HORIZON®. HRZ-D MANUAL
ADDENDUM
June 1980

ADDENDUM to: HRZ-D MANUAL, REVISION_1

JUNE 4, 1980

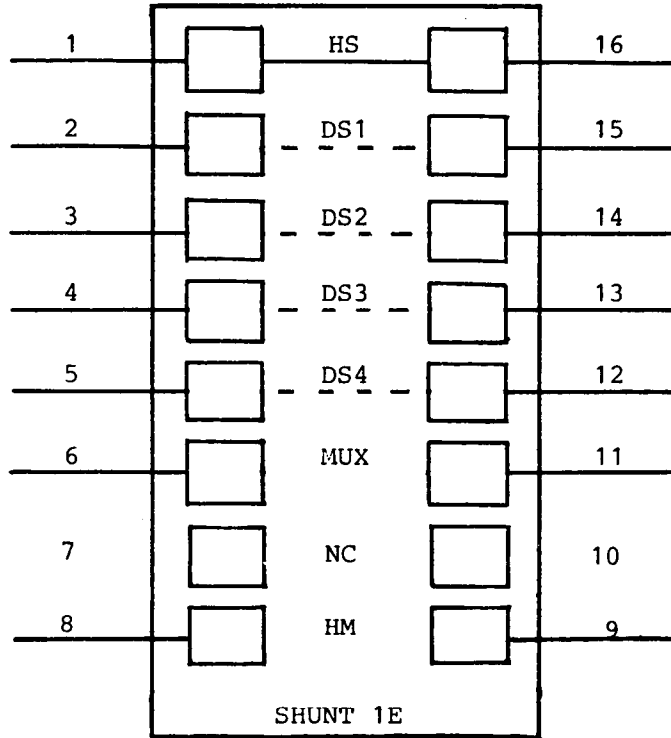
- 2) The HRZ-D Manual is the proper documentation for North Star's quad capacity HORIZON, HRZ-Q. Quad capacity HORIZON systems are essentially the same as double density HORIZON systems (HRZ-D). They differ from double density systems in that the one or two drives included with quad capacity system are quad capacity drives and not double density drives, as included in a double density system. Furthermore, the blank diskette included with a quad capacity HORIZON system is a double-sided diskette, not a single-sided diskette as included with double density HORIZON systems. In all other ways, the quad capacity HORIZON systems are the same as the current double density HORIZONS.
- 3) The capacitors C5, C6, C8, and C9 will no longer be installed in the HORIZON motherboard. Make the following changes to the HRZ-D Manual, Rev. 1:

- A. On page 12, in the section titled DISK SUB-SYSTEM (MDS-H) PARTS LIST, delete two .047uf ceramic capacitors from the parts list.
- B. On Page 13, in the section titled SECOND DISK DRIVE (HRZ-DRV) PARTS LIST, delete two .047uf ceramic disc capacitors from the parts list.

- A. On page 37, delete instruction D1 in the section titled DISK DRIVE #1 POWER REGULATION ASSEMBLY.
 - B. On page 38, delete instruction E1 in the section titled DISK DRIVE #2 POWER REGULATION AND CABLE ASSEMBLY.

DOUBLE-SIDED DRIVE SELECT CONFIGURATION

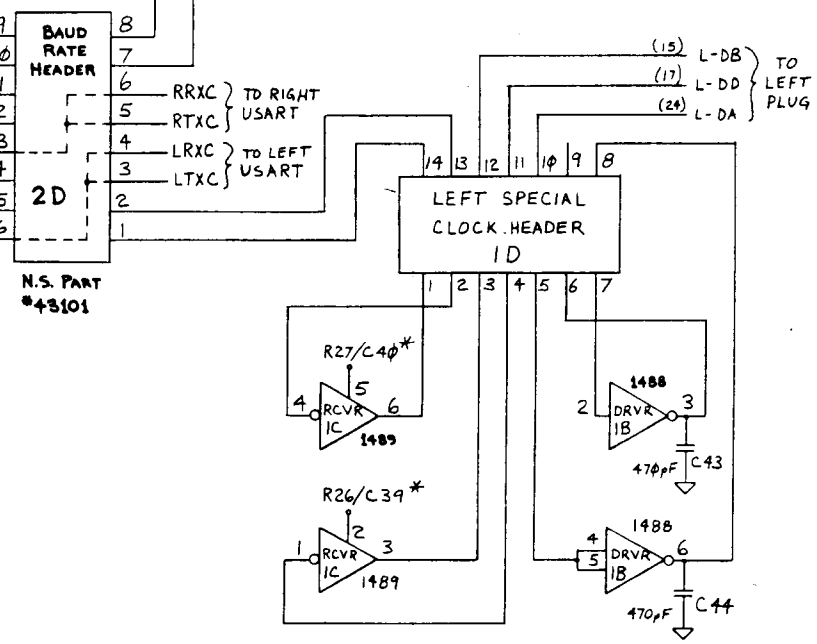
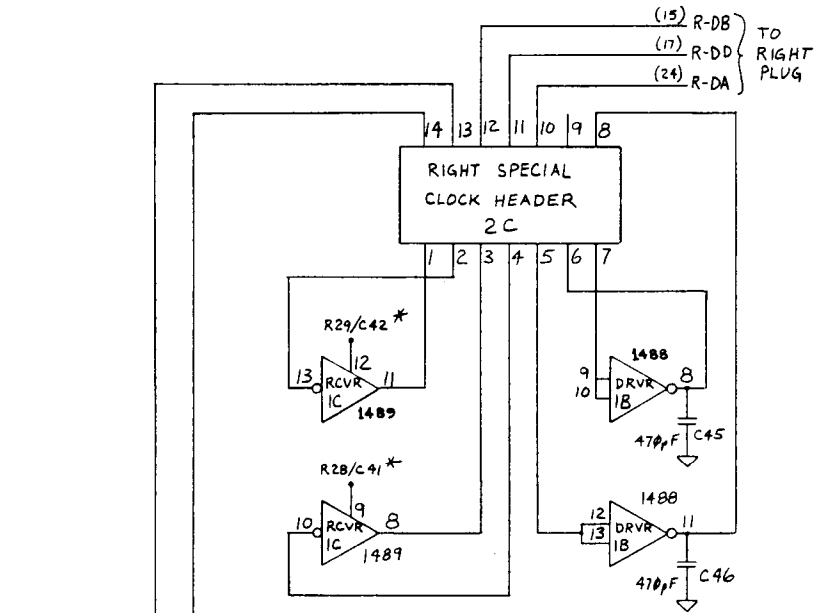
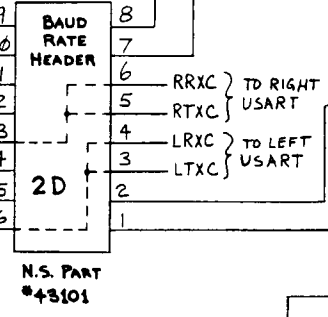
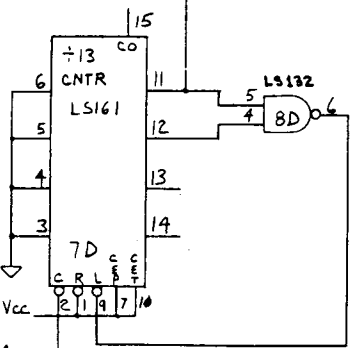
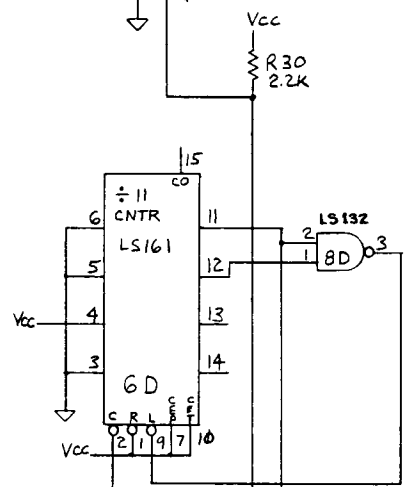
- 10) When using a doubled-sided drive, make certain that the shunt at 1E is properly configured. The connection for HS (Head Select) is connected between pin 1 and 16. To select drive one, (DS1), connect pin 2 to pin 15. To select drive two, (DS2), connect pin 3 to pin 14. To select drive three, (DS3), connect pin 4 to pin 13. To select drive four, (DS4), connect pin 5 to pin 12 and to pin 34 of edge connector J1; also, cut trace from pin 6 of the edge connector. Pin 6 and 11, the (MUX shunt), pins 8 and 9 (the HM shunt) and pins 7 and 10 should not be connected. For proper pin configurations, see the "Double-Sided Drive Select Configuration" diagram on the next page.

- Only the drive plugged in at the end of the ribbon cable should have the DIP resistor network at location 2F plugged in. Additional drives plugged in along the cable should have the resistor package removed.

HORIZON MOTHERBOARD HRZ-MB-4	SHT
SERIAL PORTS	3 OF 5
© 1977, NORTH STAR COMPUTERS, INC.

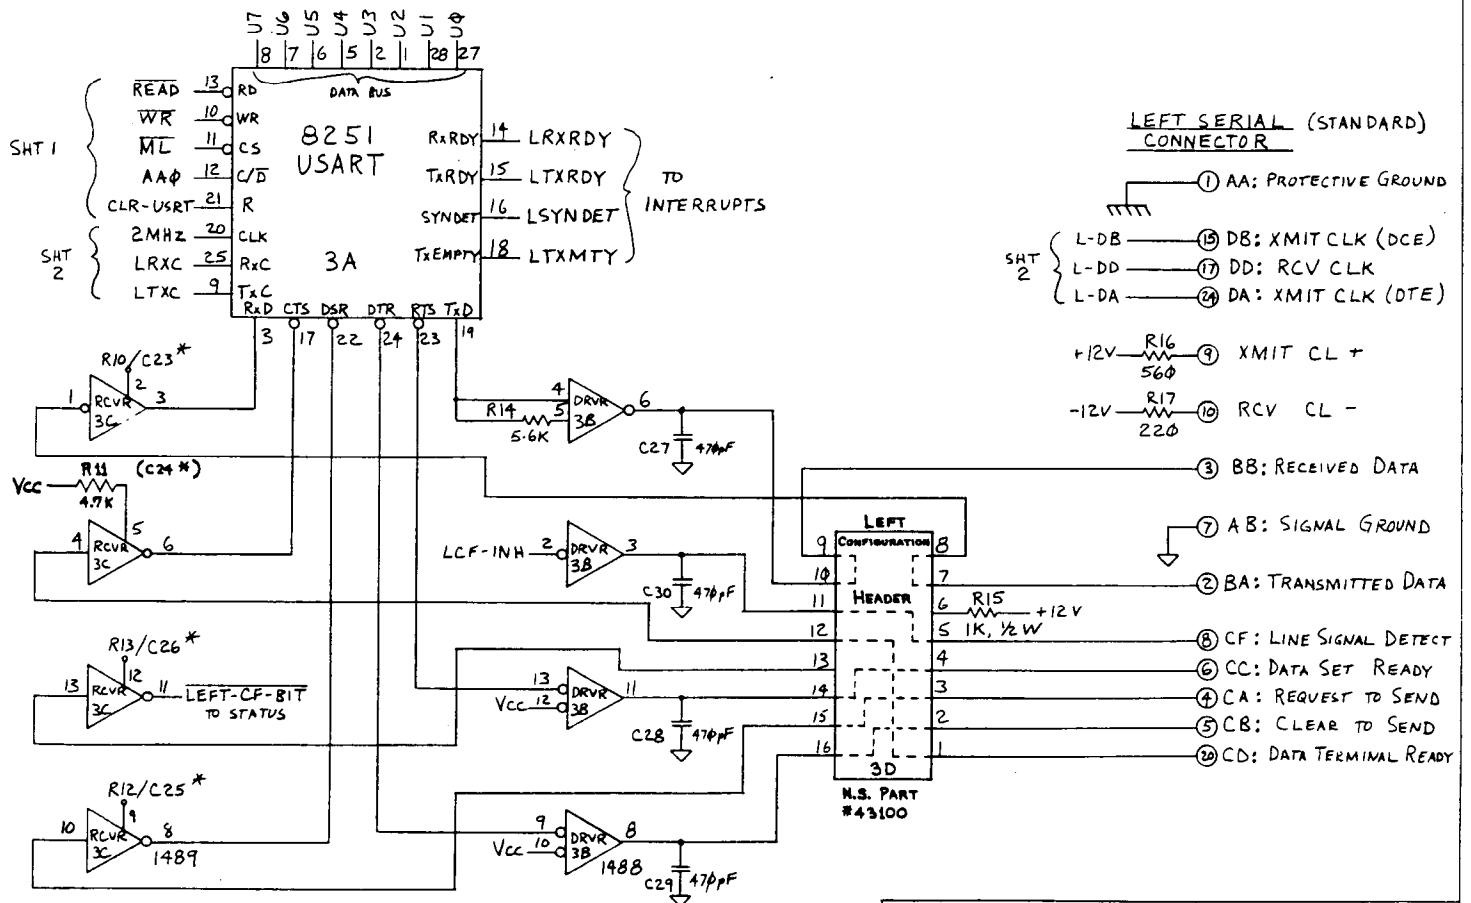
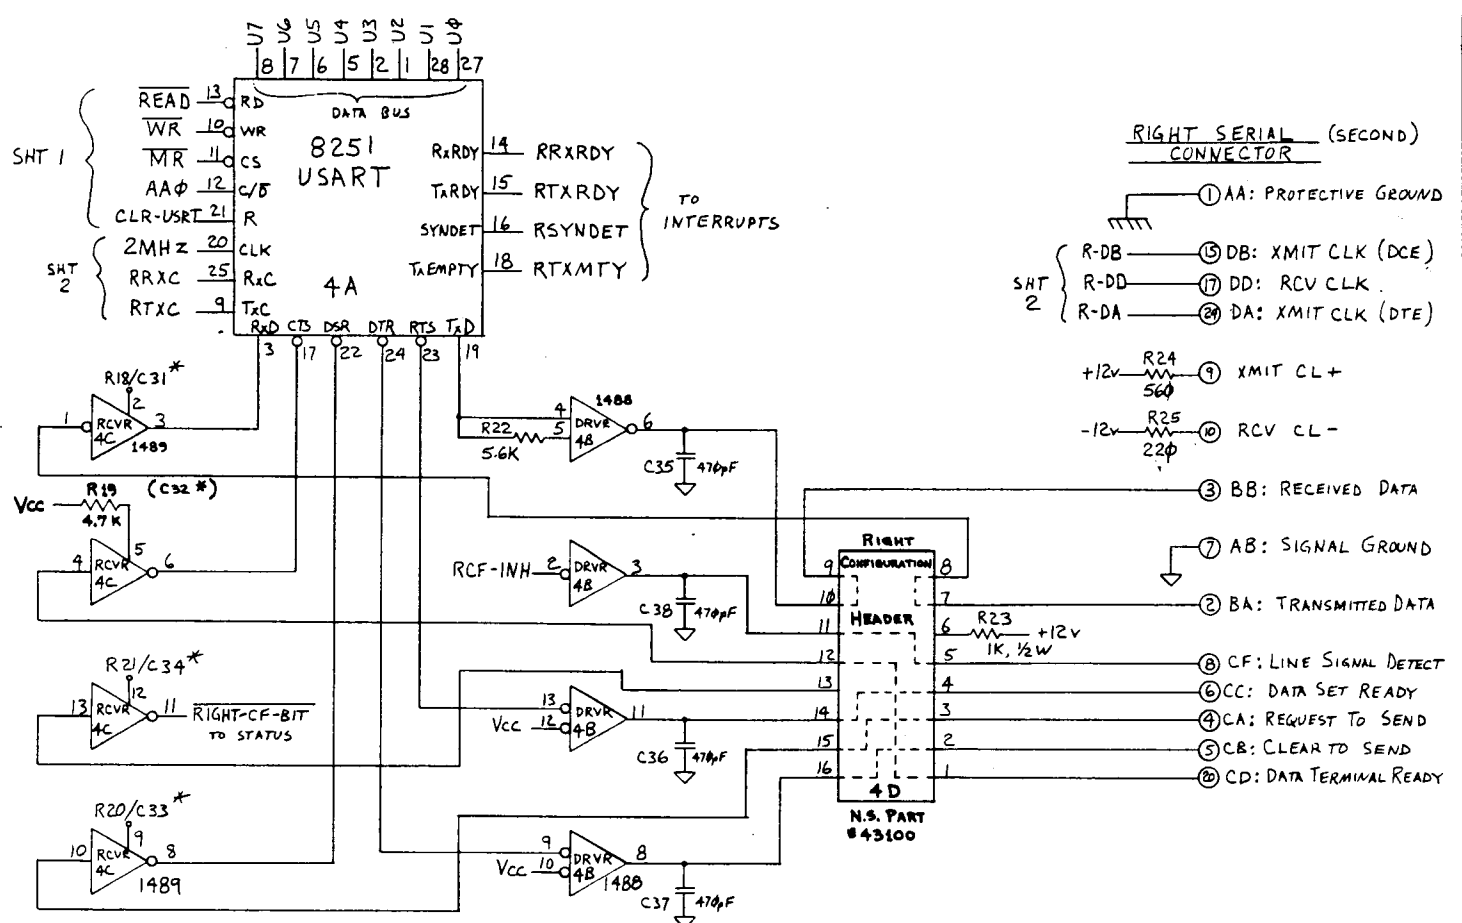
11) For all HORIZON Computer Systems containing motherboards marked "HRZ-MB-4", the following five pages of schematic drawings supersede pages 88, 89, 91, and 92 of the HORIZON Manual.

* NOTE: TO EACH RS232 RECEIVER (12 PLACES), USER MAY ADD RESISTOR TO Vcc OR CAPACITOR TO GND. (4.7K RESISTOR NOMINALLY INSTALLED AT PIN # 5)

HORIZON MOTHERBOARD HRZ-MB-4	SHT
BUFFERS, STATUS, PARALLEL PORTS	4 OF 5

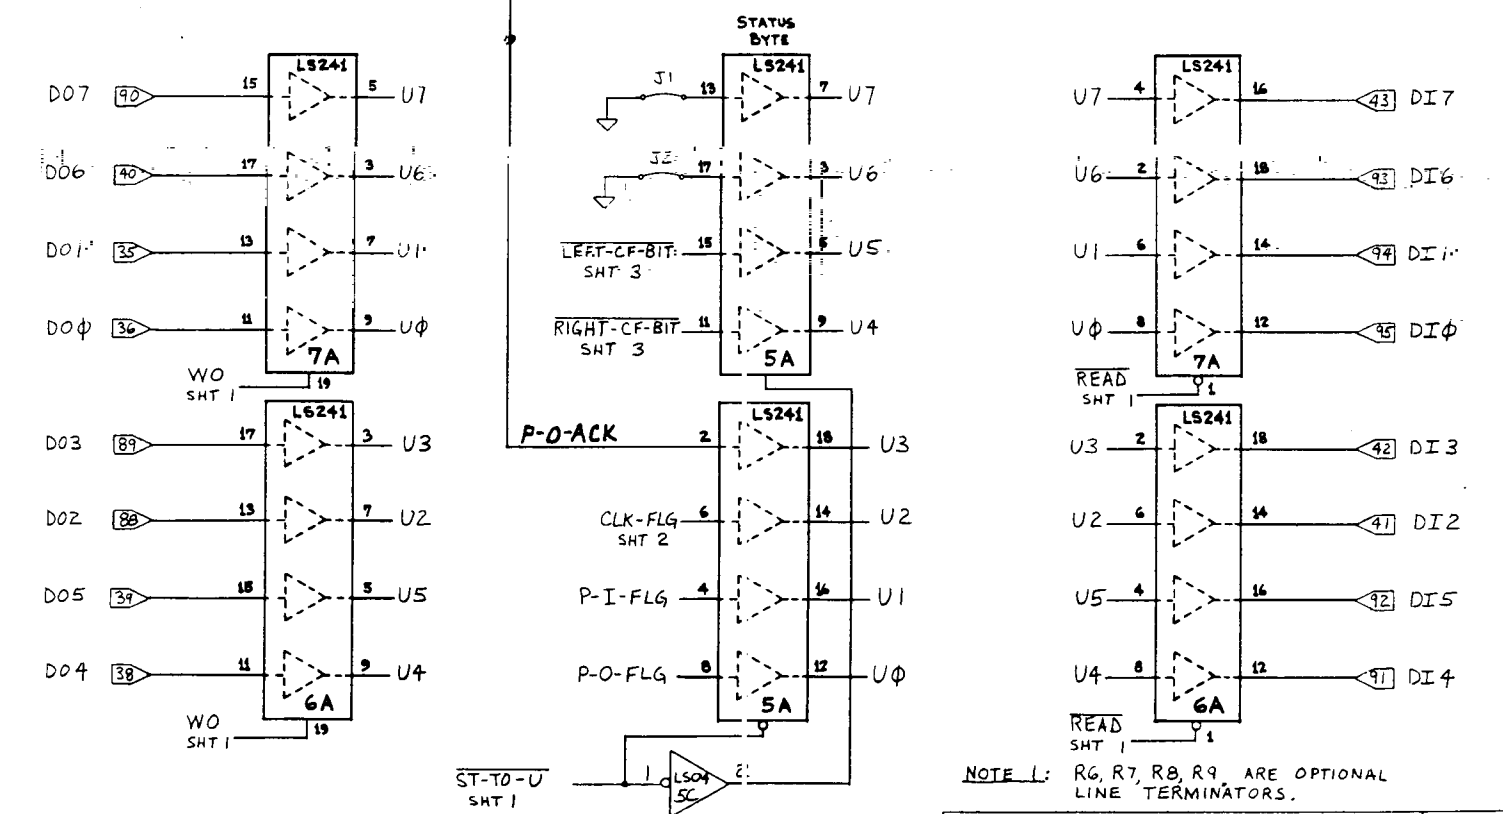
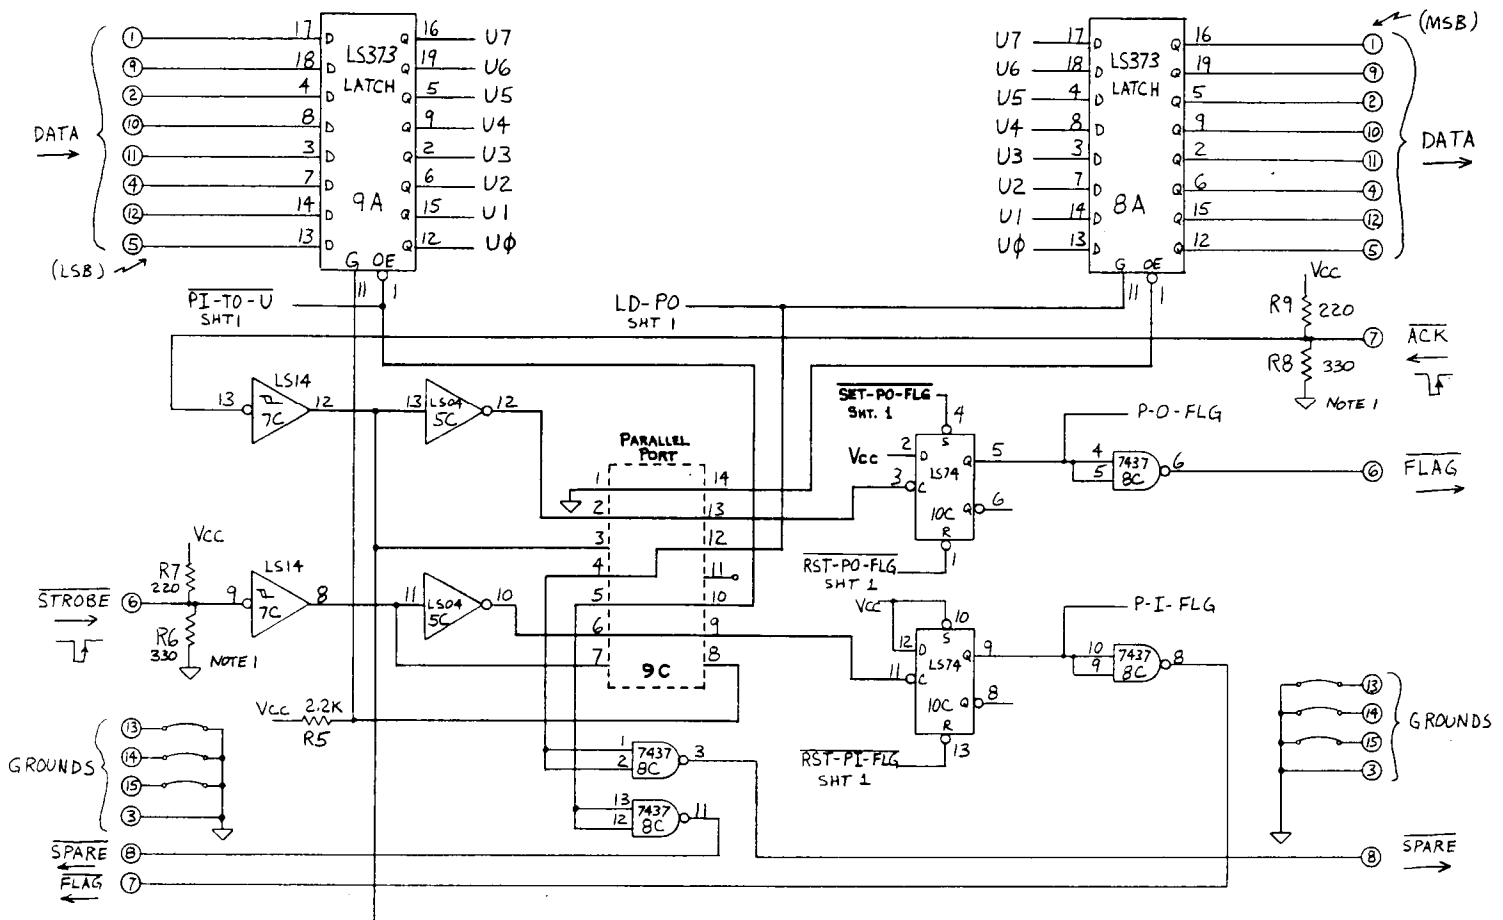
NOTE 1: R6, R7, R8, R9 ARE OPTIONAL LINE TERMINATORS.
